POTENTIALLY UNQUALIFIED COMPONENT IN CERTAIN ALLEN BRADLEY TIMING RELAYS

UPDATE - Report of potential 10CFR Part 21, Allen Bradley Timing
Relay Model 700RTC
Report No: P21-04302015, Rev. 2

Part 21 Report No: P21-04302015, Rev. 2

Subject: **Update** - Report of potential 10CFR Part 21, Allen Bradley Timing Relay Model 700RTC – NRC Event Number 51030, Accession Number ML15134A016

Figure 1- Original qualified design (prior to 2009).
Relays supplied prior to 2009 are not affected by this issue.

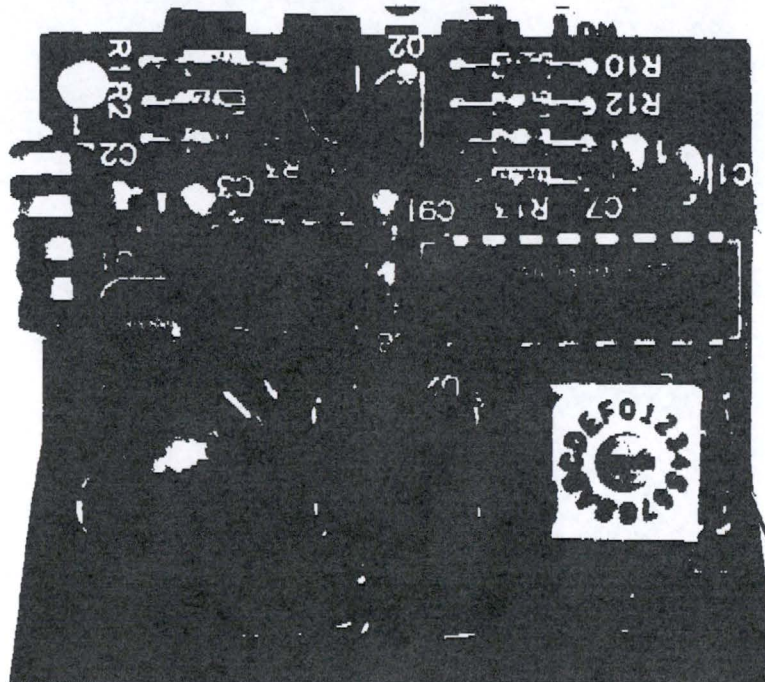
Between 2009-2010, Allen Bradley made a design change without changing the part number of the commercial relay or providing any documented evidence of a design change. The manufacturer specification data sheets maintain the classification that the relays are "solid state", which would imply that there are no digital devices installed in the relay. However, after inspection of the internals of the timing relay (Figure 2), it has been identified that the unit does contain a CPLD which meets the definition of a digital device under the guidance of NEI 01-01. See Figures 1 and 2 below:
